SERVICE BULLETIN

Date: 5/23/2005
Service Bulletin #: PDSBLTN-002, RWSBLTN-230505
Subject: Inspection of Tandem VTC-III reserves (VR-360) A Line Attachments and Steering Lines.
Status: MANDATORY

Relative Workshop Tandem 360 reserve part number VTCIII, manufactured by Performance Designs Inc.,

Correct Brake Setting

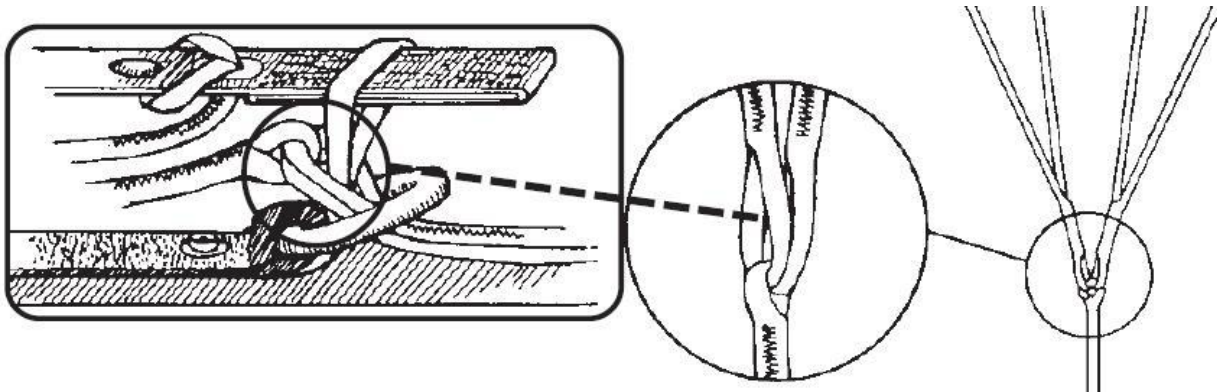
Some VR-360's were manufactured with the lower control line loop to be as large as the upper control line loop at the cascade. While there is no impact to the structural integrity, or performance of the canopy, this situation opens the possibility for the riser brake-setting loop to be misrouted through the lower control line instead of the correct location in the upper control line as shown below. Improperly set brakes can result in brake line failure during opening and unusually high opening forces.

Figure 1 Rib leading Edge Tape Inspection

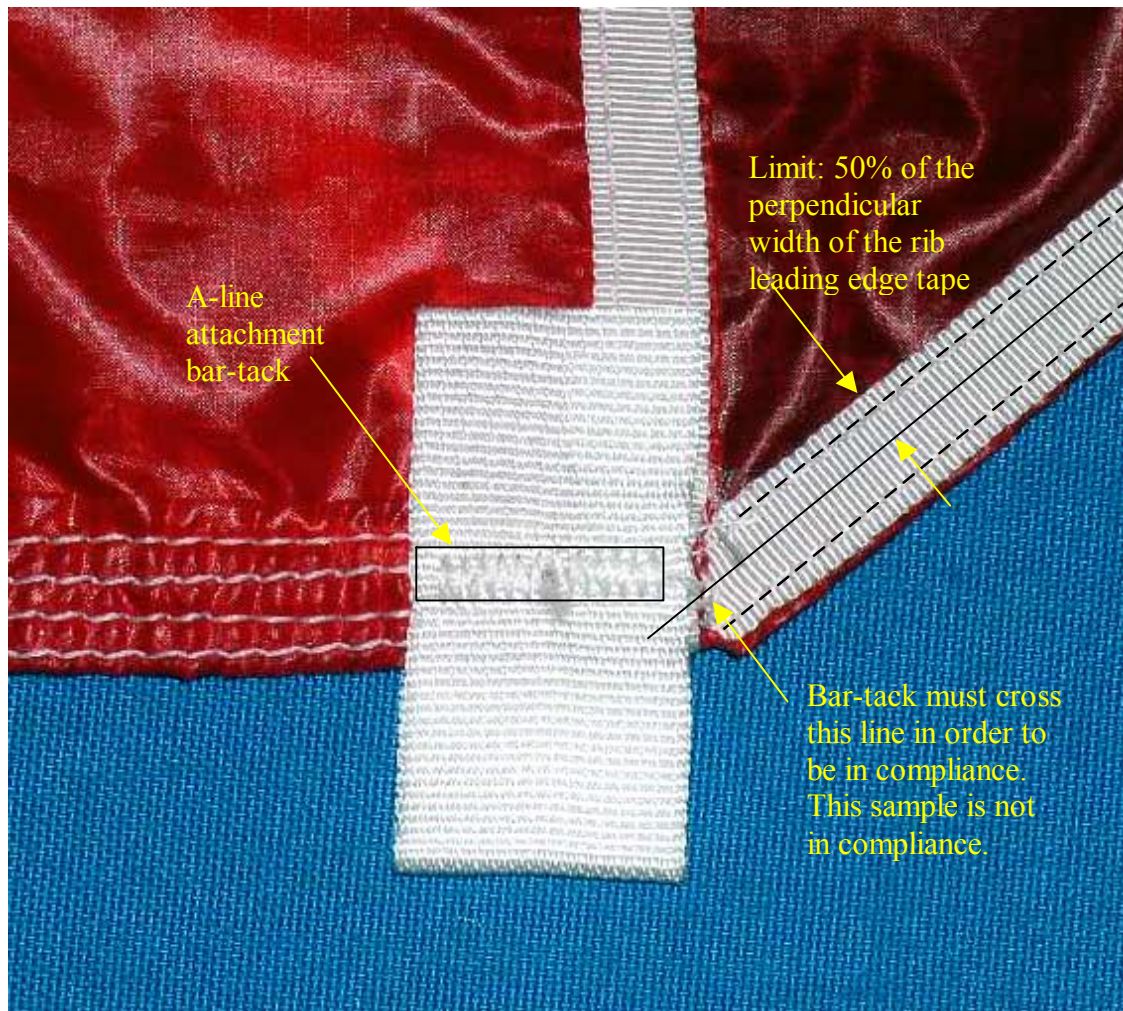
The A-line attachment bar-tack must be sewn through at least 50% of the width of the loaded-rib leading edge tape.

- Using a ruler, find the centerline of the rib-leading edge tape. This may be lightly marked with pencil if necessary.
- Using the ruler, extend the centerline of the leading edge tape to the vicinity of the bar-tack.
- Observe the location of the bar-tack with respect to the tape centerline.

Figure 2- Bottom Skin LE Tape Inspection

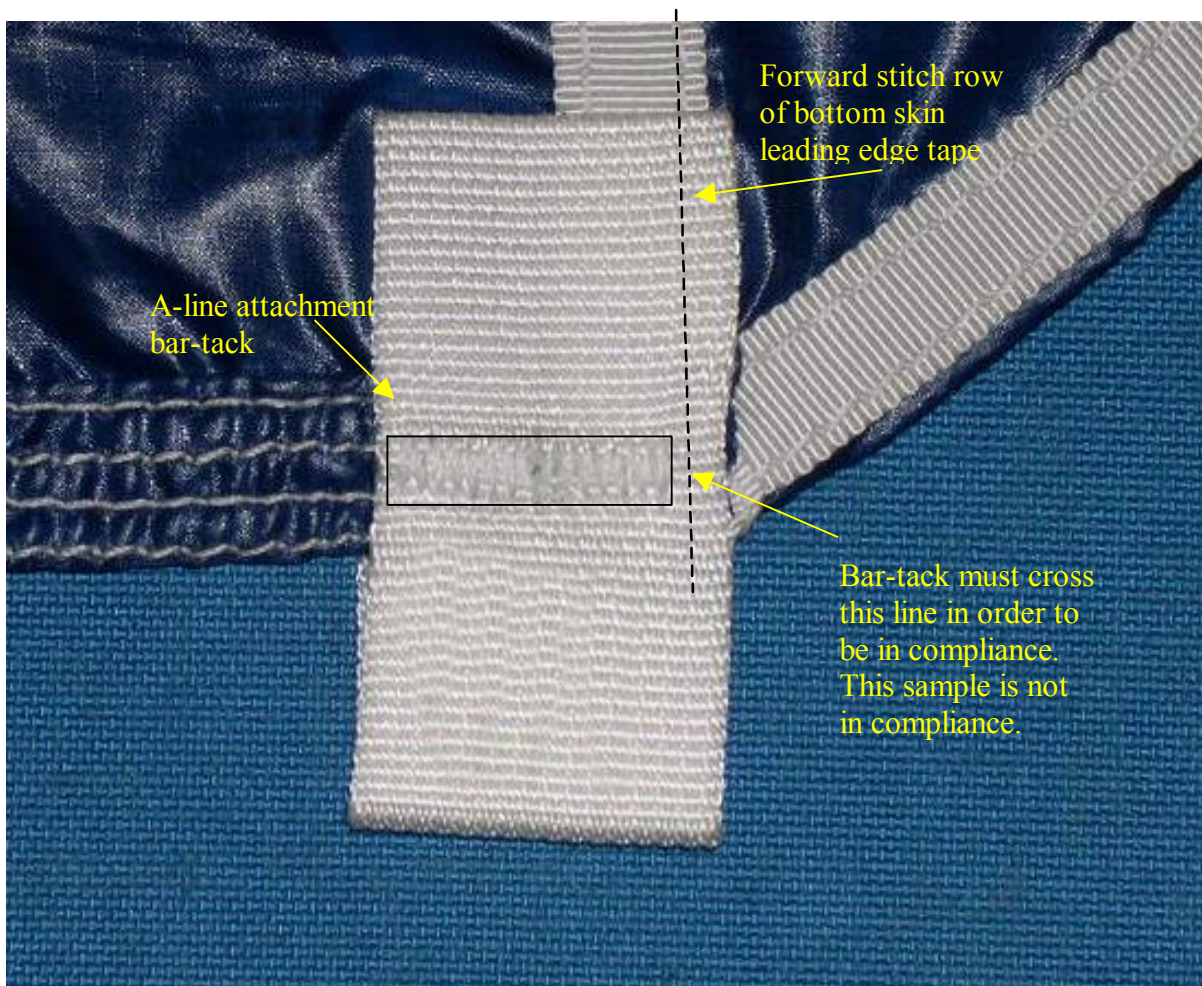
The A-line attachment bar-tack stitching must extend forward of the forward stitch line on all the bottom skin leading edge tapes. Inspect both sides of tab.

- a) Locate the forward stitch row of the bottom-skin leading edge tape.
- b) Using a straight edge, extend the forward stitch line of the leading edge tape to the vicinity of the bar-tack.
- c) Observe the location of the bar-tack with respect to the tape stitch row. The bar-tack may or may not overlap the edge of the line-tab, but it must cross the stitch-row and be going through the tab at this point.

Figure 5 Good LST Loop

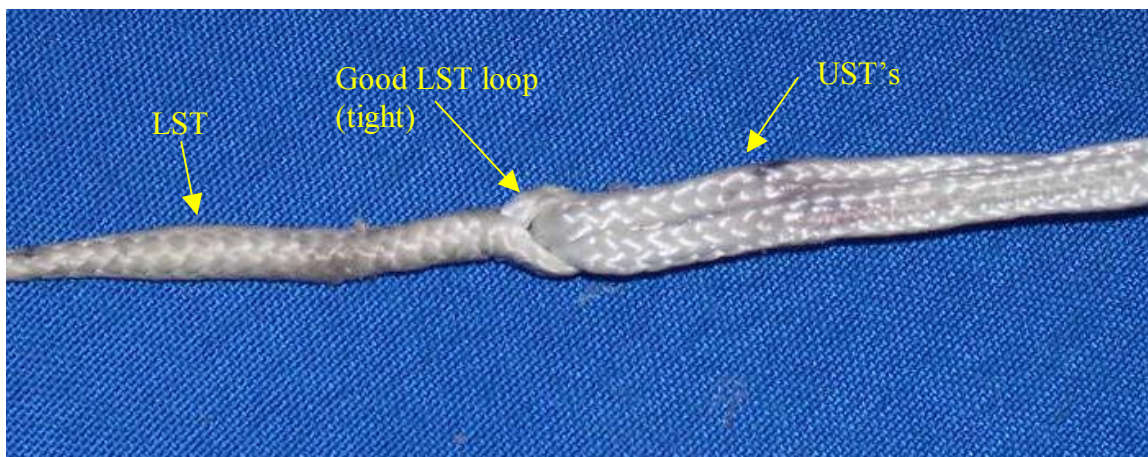
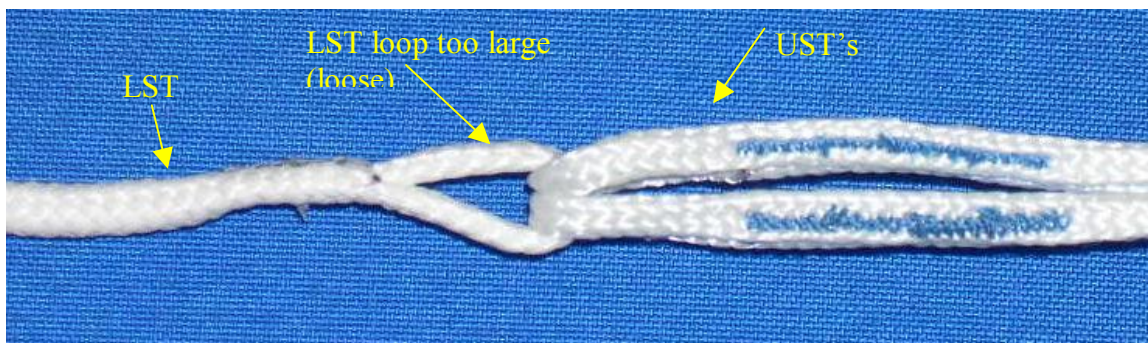
Check each of the LST's (lower steering lines, the line that passes through the toggles) where it loops around the UST (upper steering line). This loop must be small enough that the brake setting loop on the risers cannot be pulled through.

Using Figures 7 and 8, evaluate the LST loops.

Figure 7 Top View, LST Loop Adjustment

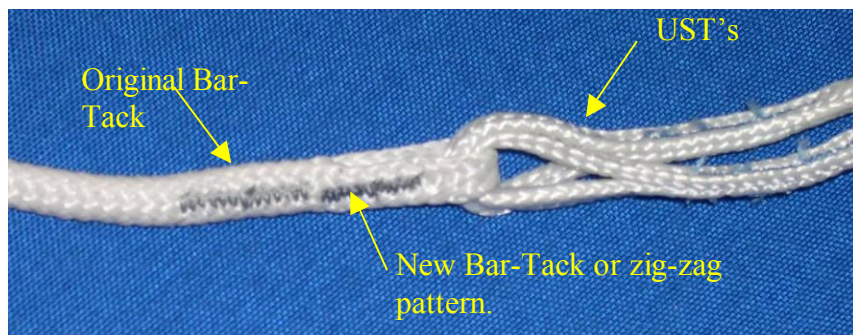
The stitch shall be installed to the legs of the LST loop between the existing bar-tack and the loop around the UST lines as shown in Figure 9. The UST's may be left in place while this work is done, given sufficient care to avoid stitching thru the UST material.

The work must be performed by a certificated rigger. The stitching must be Nylon E-thread. Stitching may be done with a single throw zigzag, double throw zig-zag, or a bartacker with between 28 and 42 stitch conventional or center start pattern. Stitch pattern should be between 1/2" and 5/8" long, and 1/8" wide. For zigzag stitching, the preferred pattern is to start at or near the existing bartack, sew toward the UST, and then reverse back to the starting point. Zigzag stitching shall be 12 to 16 stitches per inch for single throw, and 8 to 12 stitches per inch for double throw.

Figure 8 Side View, LST Loop Repair.

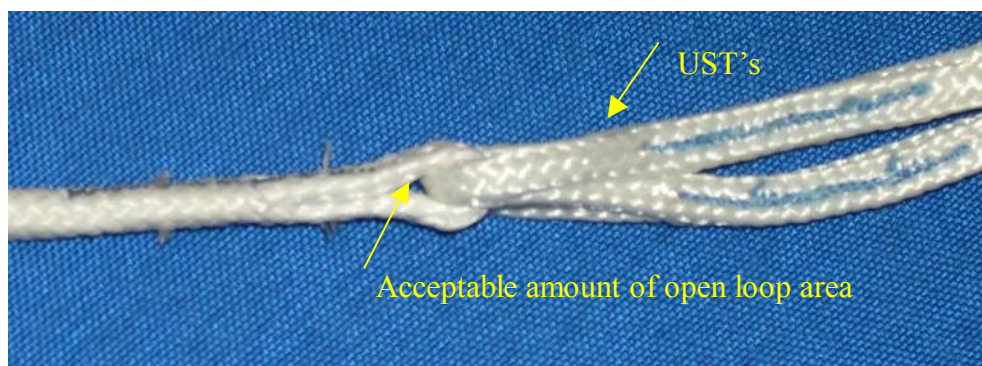
The stitching shall not overlap the existing bar-tack or penetrate the UST material passing through the loop. See Figure 10. A small amount of open area within the loop is permissible after the repair.
